RE: Evaluation of Alluvial aquifer background concentrations for Contaminants of Concern for the Homestake Mining Company Superfund Site (CERCLIS ID NMD007860935), Cibola County, New Mexico

Statistical Evaluation of Alluvial Groundwater Quality Upgradient of the Homestake Site Near Grants, New Mexico: Molybdenum, Selenium, Uranium

Reviewed by:
Richard J. Abitz
Geochemical Consulting Services, LLC
April 2009

Figure 1. Systematic grid and random points on a grid are the statistically valid methods for locating background wells.

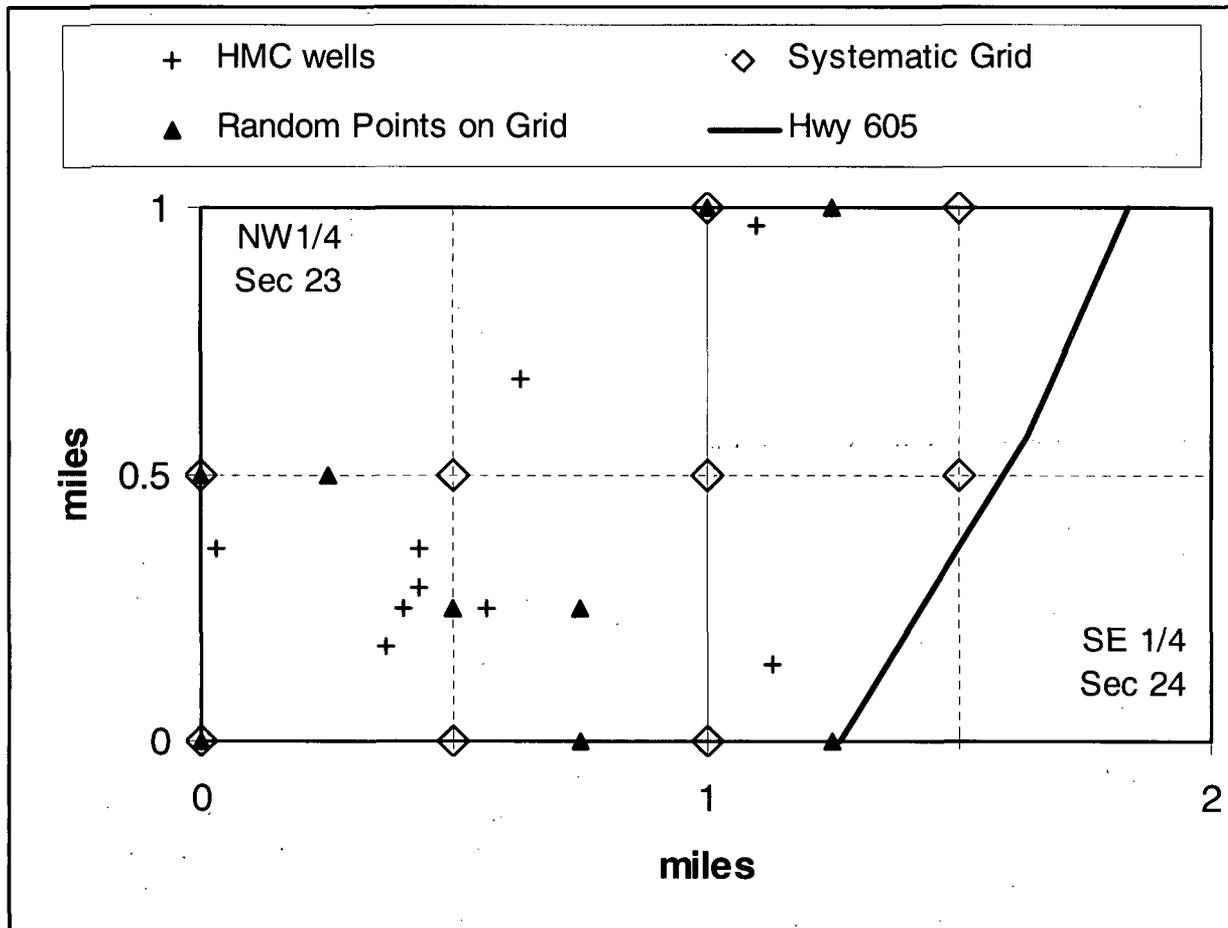
Figure 1 illustrates the location of HMC's near upgradient wells in Sections 23 and 24, relative to wells that are located on a systematic grid or as random points on a grid. Assuming that the nine HMC wells are the proper density over the given area, nine locations on a systematic 1/2 by 1/2 mile grid (open diamond symbols) or nine random locations selected from the nodes of a 1/4 by 1/4 mile grid (filled triangles) illustrate the proper statistical methods for locating background wells. There is no statistical justification for the location of the present HMC wells used in this study.

Figure 2. Variation in uranium concentration at well DD over a 22 year period.

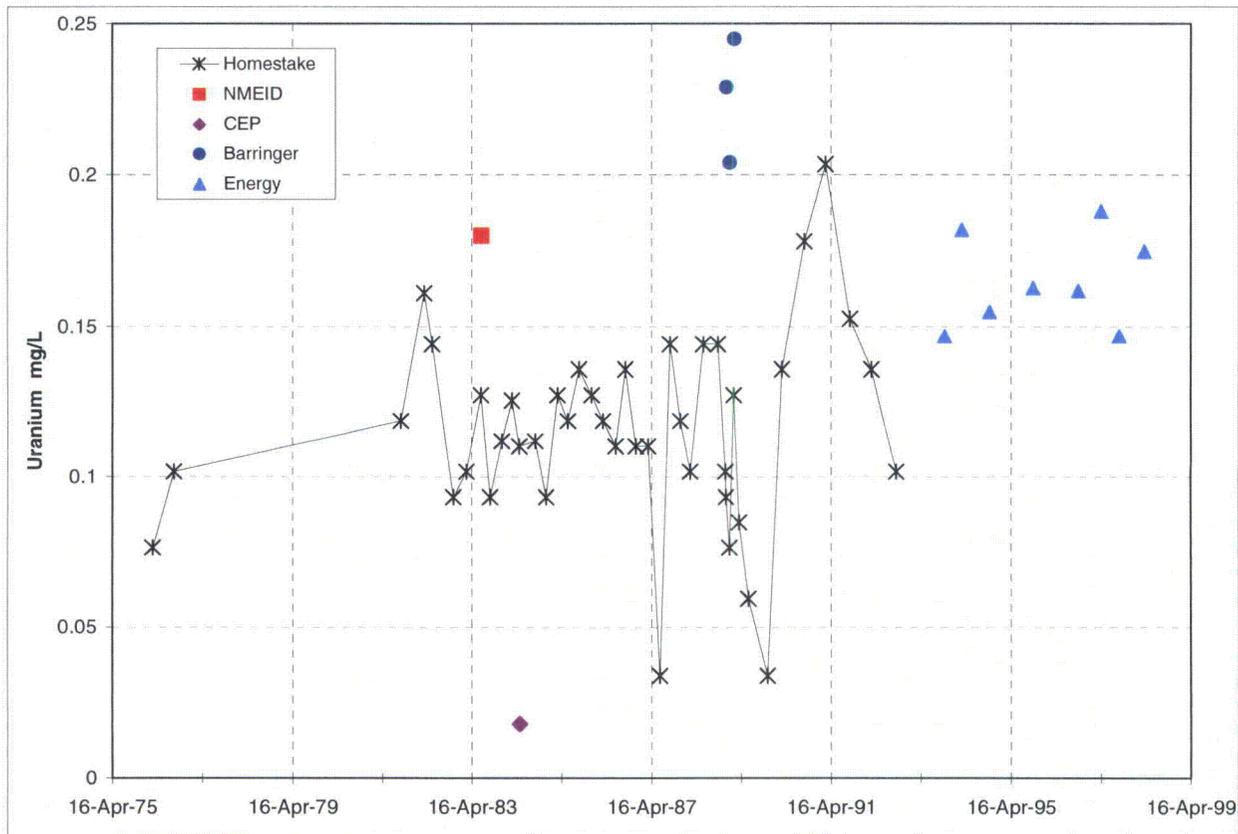
For example, at well DD, the 08Dec88 result for uranium is 0.102 mg/L, and this is followed by average values of 0.161, 0.140, and 0.186 mg/L for three rounds of split samples (13Dec88, 11Jan89, 15Feb89) and then back to 0.0848 mg/L on 29Mar89 (see Table 75, page 172 of the ERG report). Averaging the split samples from Homestake and Barringer produces results that are 60 to 100 percent greater than the single results that bracket the split samples. The gross difference in the Homestake and Barringer split results, as well as differences between Homestake, NMEID and CEP, are shown on Figure 2.

Additionally, there is a noted change in the uranium concentration at well DD on 21Oct93, and this reflects a change in the analytical laboratory (Homestake before 21Oct93 and Energy Laboratory on 21Oct93 through 1Apr98). Figure 2 illustrates that prior to 21Oct93, only 4 samples exceeded 0.147 mg/L, whereas after this date all samples are above this value. This shift in values could reflect methods and equipment at different laboratories or it may indicate the arrival of additional contamination at the well. Although the large swing in values reported by Homestake Laboratory over the period 16Apr89 through 16Apr93 suggests analytical and/or sampling problems.
